Planning and Zoning Board Agenda February 12, 2019

- C. Site Plan - San Felasco Hammock State Park Shop Building: A request by Michael Freidin of George & Associates, Consulting Engineers, Inc., applicant and agent for the State of Florida, property owner, for consideration of a Site Plan for the construction of a ±2,030 square foot shop building on a ±.33 acre project area on a ±300 acre subject property. Tax Parcel No. 04033-000-000 (Quasi-Judicial)

- D. Upland Industrial Park, Lots 2 - 5 Site Plan: A request by Daniel Young, P.E., LEED A.P., of Causseaux, Hewett, & Walpole, Inc., applicant and agent for Upland Properties of NCF, LLC, property owner, for consideration of a Site Plan for the construction of two (2) buildings, a ±23,439 square foot building and a ±26,682 square foot building, with associated drainage, paving, grading and infrastructure improvements, on a ±4.82 acre subject property, located on Lots 2 – 5 of Upland Industrial Park and at the terminus of NW 101st Drive; Tax Parcel Nos. 05964-002-002 through 05964-002-005 (Quasi-Judicial Hearing).

SHEET NO. C1.00

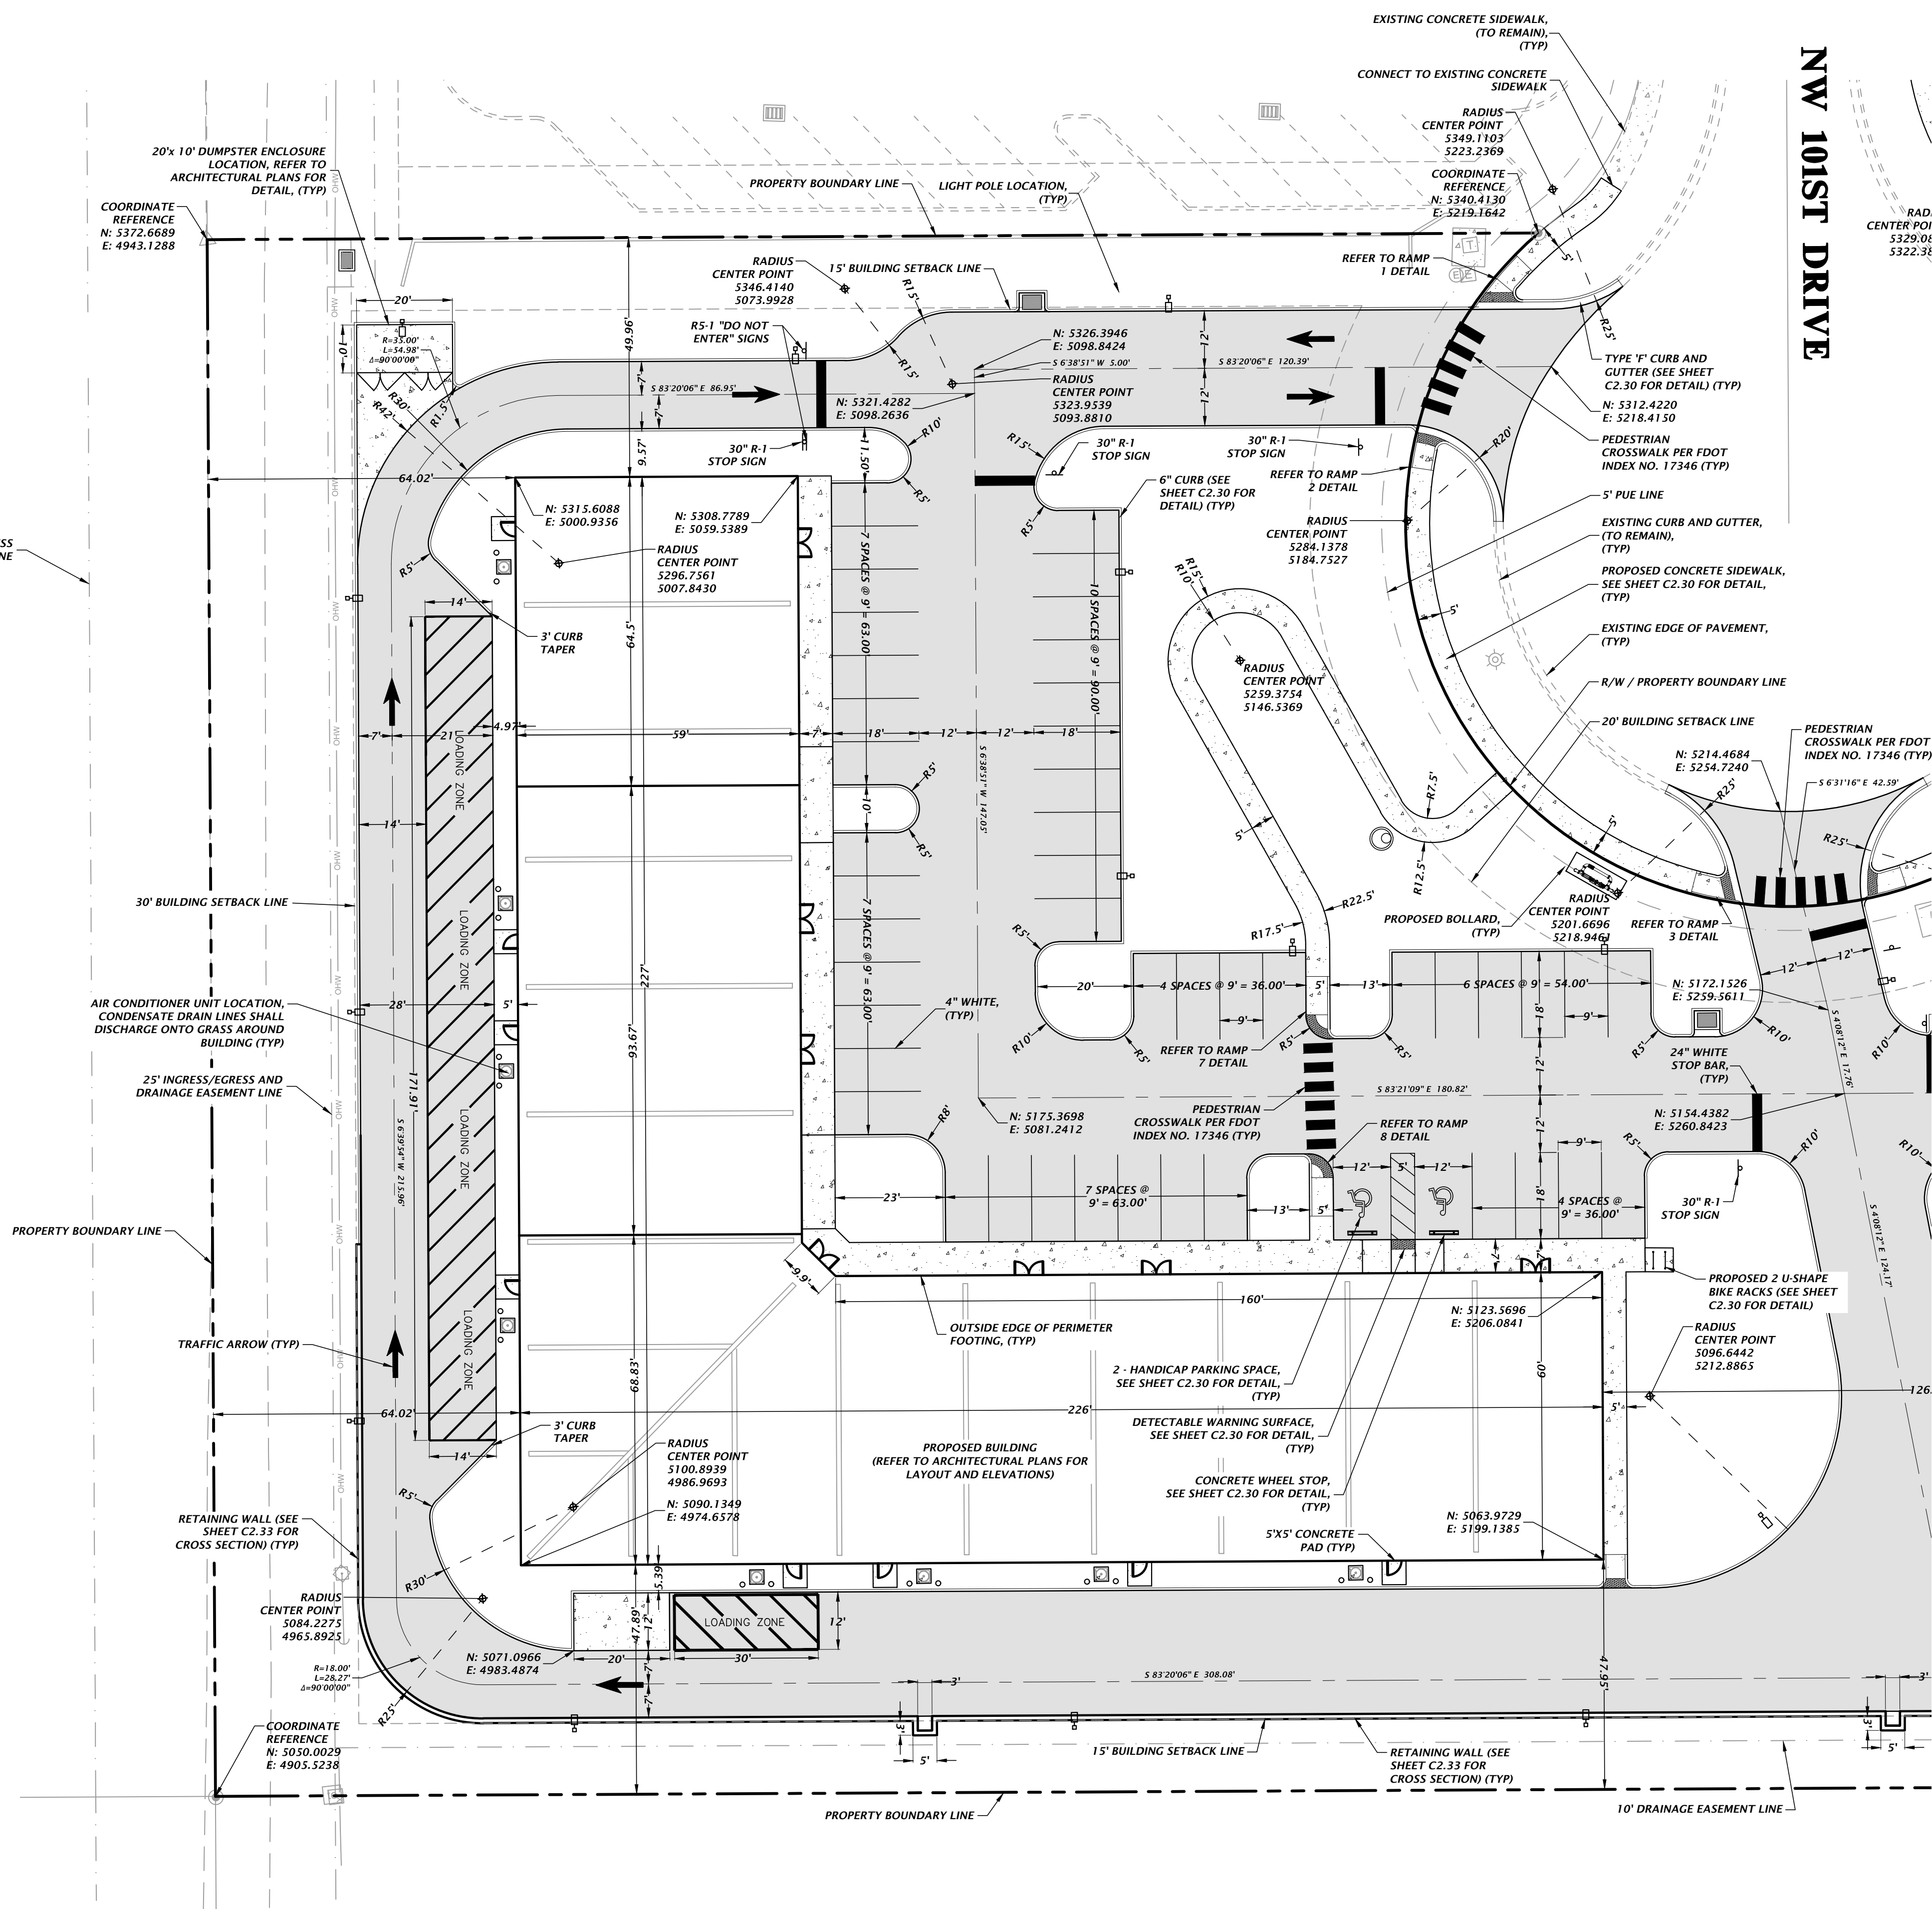
1. Add proposed door locations to the buildings to determine accessibility compliance.
2. How are delivery trucks supposed to access the back of the buildings? Each of the driveways to the rear have "Do Not Enter" signs.
3. How will the garbage truck turn around? Verify garbage truck maneuverability to the dumpster.
4. On Sheet C1.02, should the "No Left Turn" sign be a "No Right Turn" sign?
5. Specify where the AC Units will be located.
6. What type of delivery trucks are anticipated? Have AutoTurn simulations been conducted to ensure that the trucks can maneuver behind the proposed buildings?
7. Add dimensions to the loading zones.
8. Add sufficient dimensional tie down information to make the site constructible. (i.e. Add northing and eastings at the building corners.)

HANDICAP PARKING DETAIL

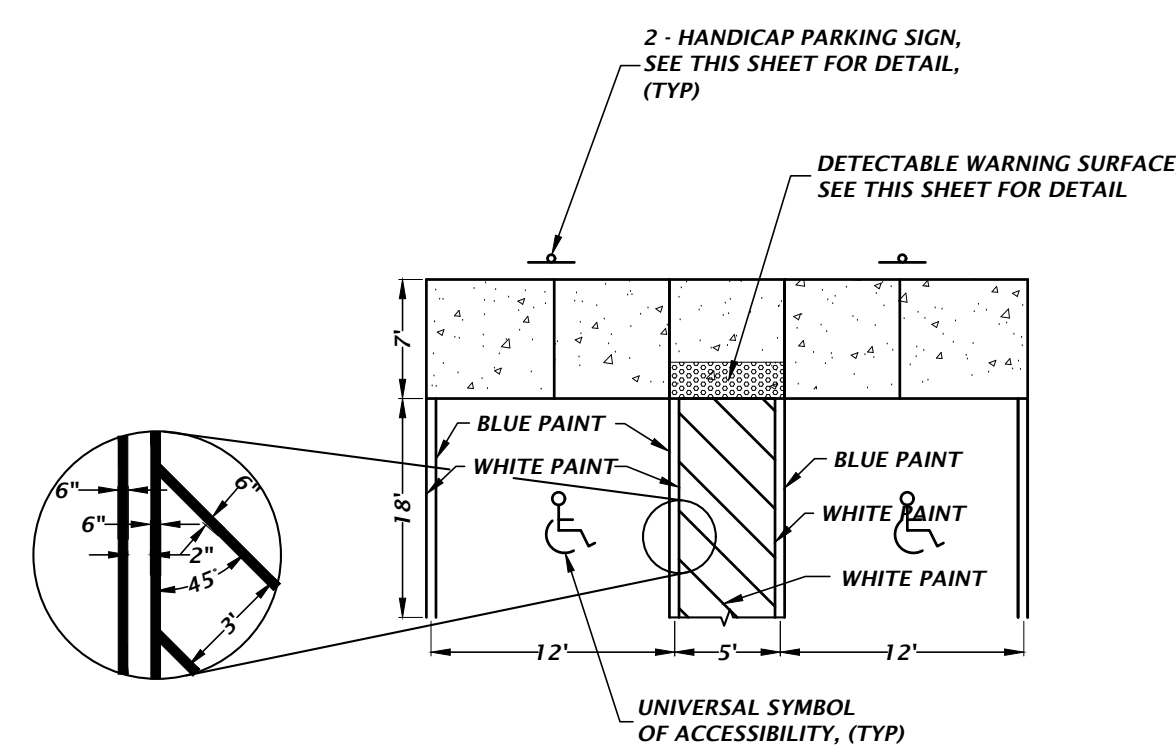
3. The Handicap Parking Detail does not agree with what is shown on Sheets C1.00, C1.01, and C1.02. Update detail to match proposed conditions.
4. Where is the Sleeve Crossing Detail used? Specify on Sheet C3.00.
5. Add details for the sidewalk ramps used or label the sidewalk ramps per the FDOT index on Sheets C1.01 and C1.02.

DETAIL No. 230 - 3/4" AND 1" WATER METER ASSEMBLY
NTS

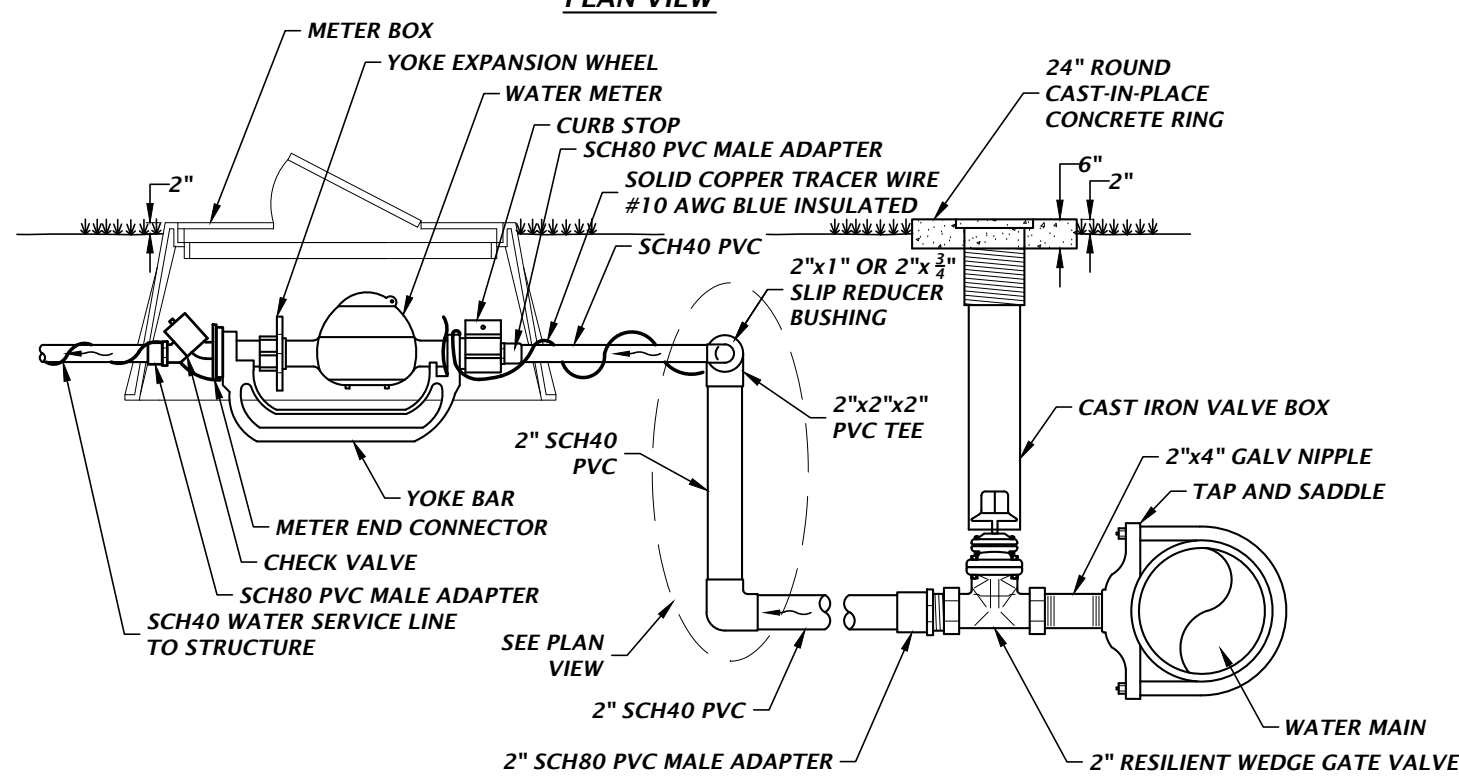
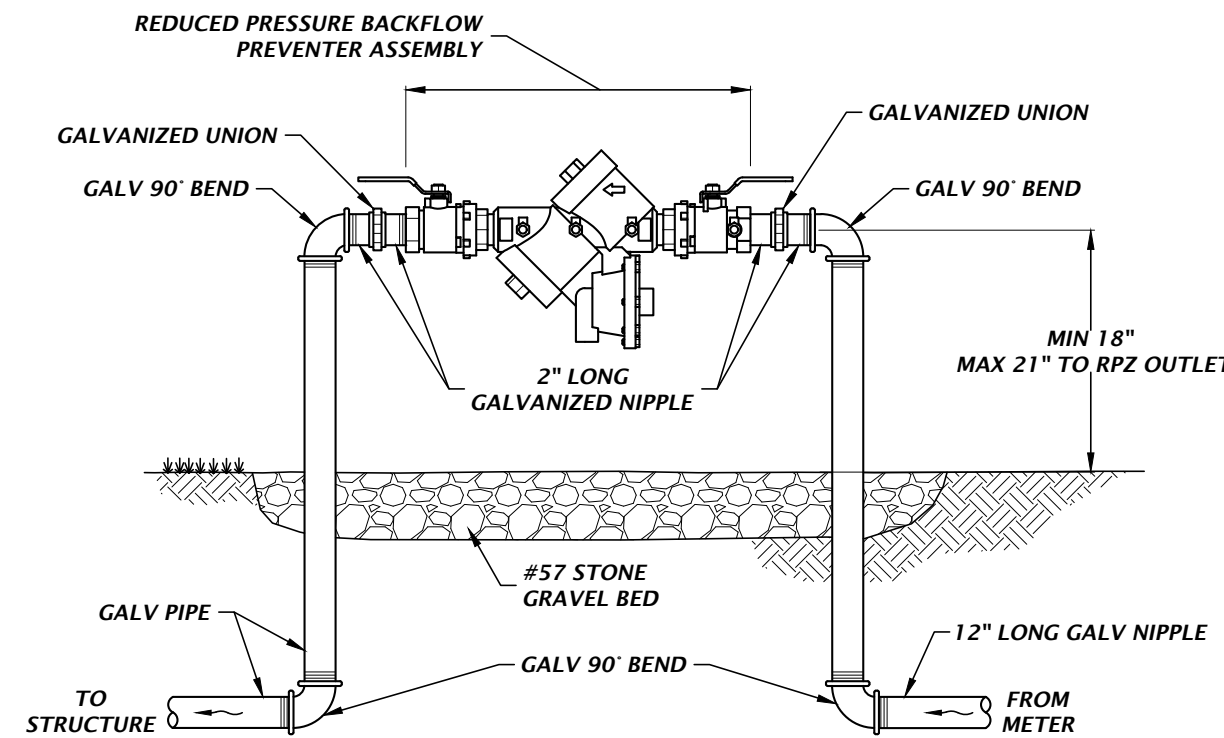
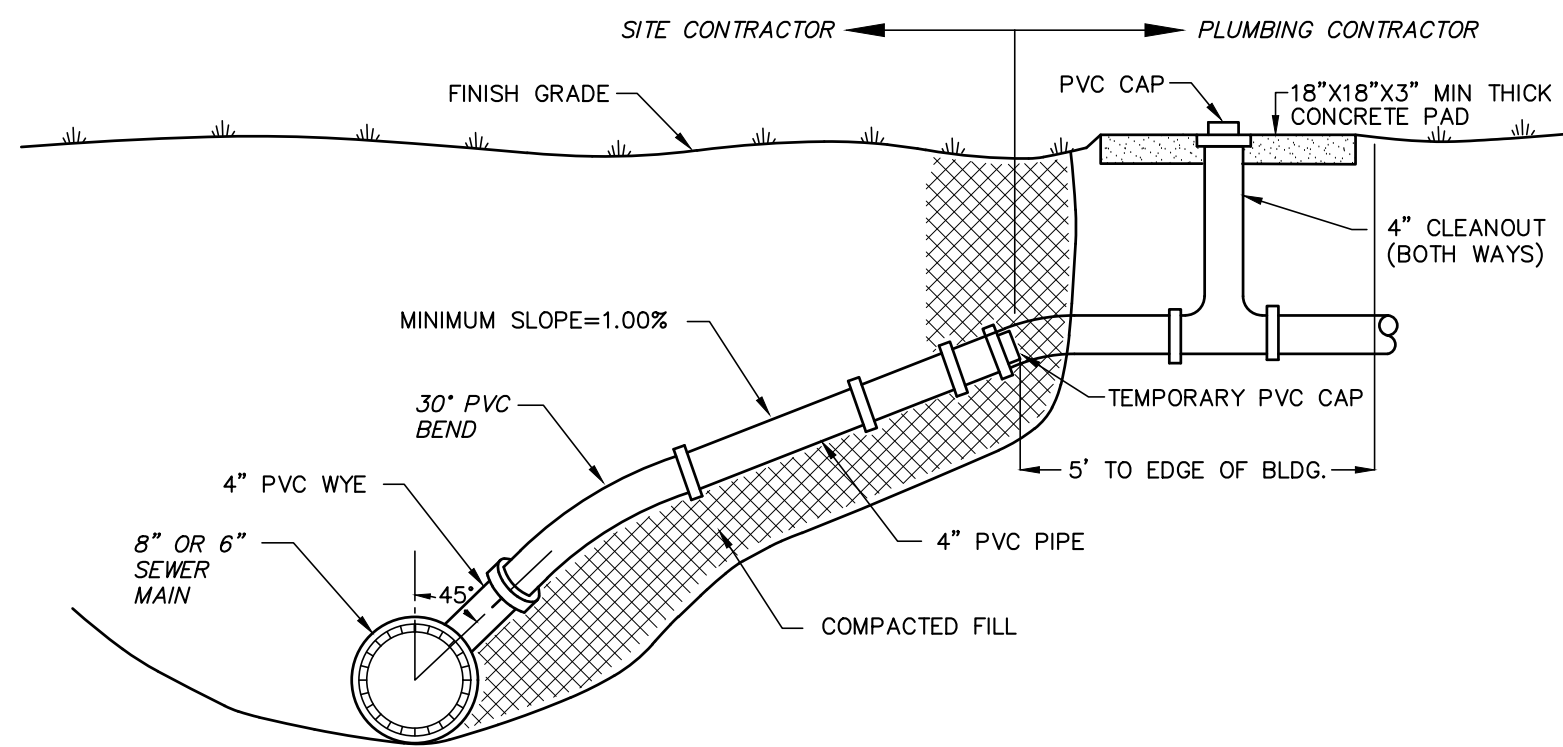
5. Within the Potable Water Connection and Water Meter Details 1 & 2, correct and add the following:
 - a. Proposed tees are not tapped.
 - b. Add weather protection to the backflow preventers.
